Proposed Revisions to a Standard Plans Index

Index Number: 715-001

Index Title: Conventional Lighting

Sheet 1: Added a detail to define luminaire tilt angle for designers and contractors; Added reference to Index 715-002 and 715-003 to the Metal Pole Detail; Changed sheet title to "Wiring and Installation Details" to capture the installation details beyond wiring.

METAL POLE DETAIL

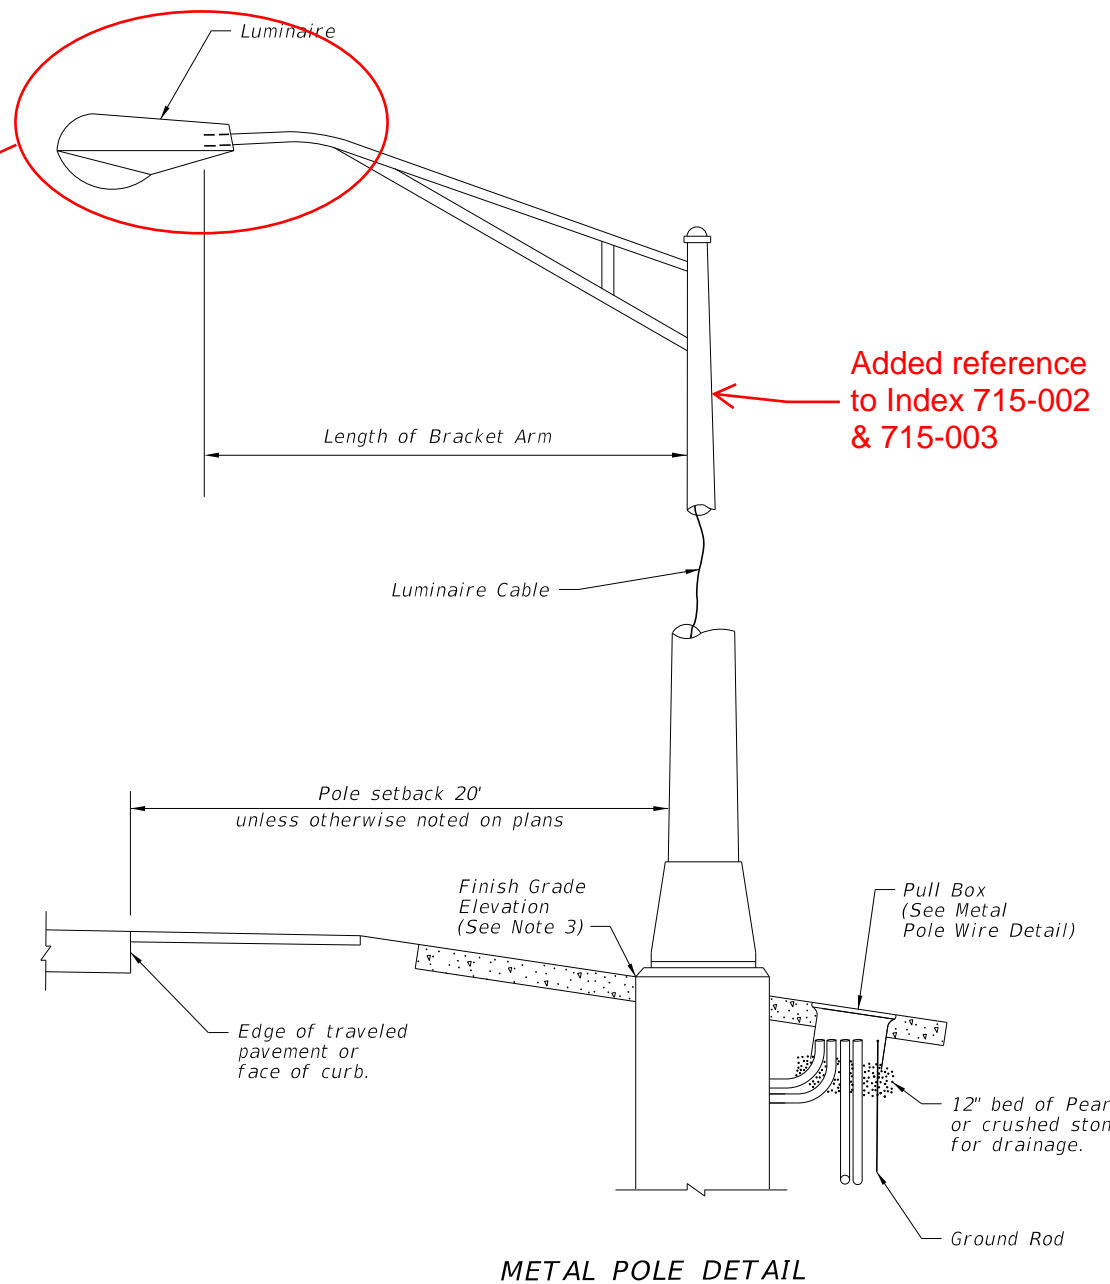
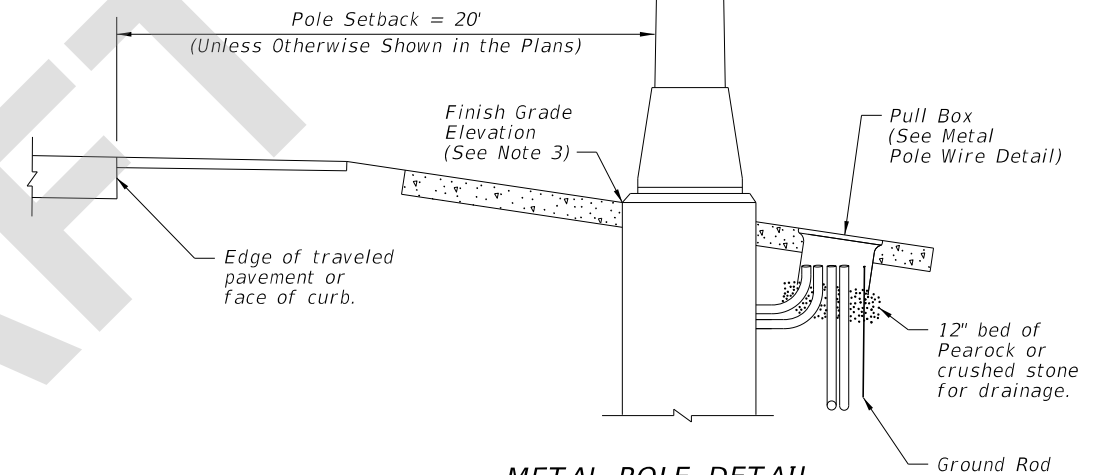
Added reference to Index 715-002 & 715-003

LUMINAIRE TILT DETAIL (Side View)

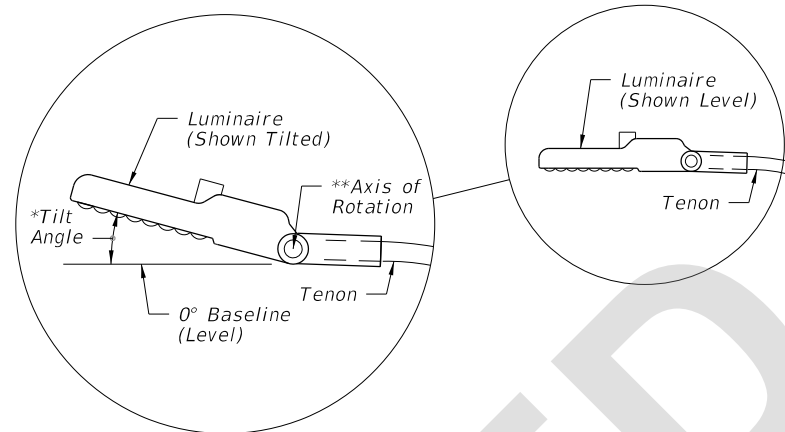
The Turnpike Design Handbook (TDH) had previously required designers to include a project-specific plans detail to explain the luminaire "tilt". As part of the TDH migration, a detail to define tilt angle is being placed into this Index in order to meet this need without requiring a project-specific plans detail. Luminaire tilt angle is a common term for lighting designers using ANSI/IES RP-8-18 national guidance and AGI32 lighting design software, but tilt angle was previously not defined for contractors. Last, this "tilt" variable is being added to the standard Lighting Table per FDM 943.

Added "Luminaire Tilt Detail"

*Tilt angle is 0° (level) unless otherwise shown in the Plans
 **Axis of rotation is level and perpendicular to the tenon.
 The location shown is approximate and may be either a hinge or a tenon connection adjustment.
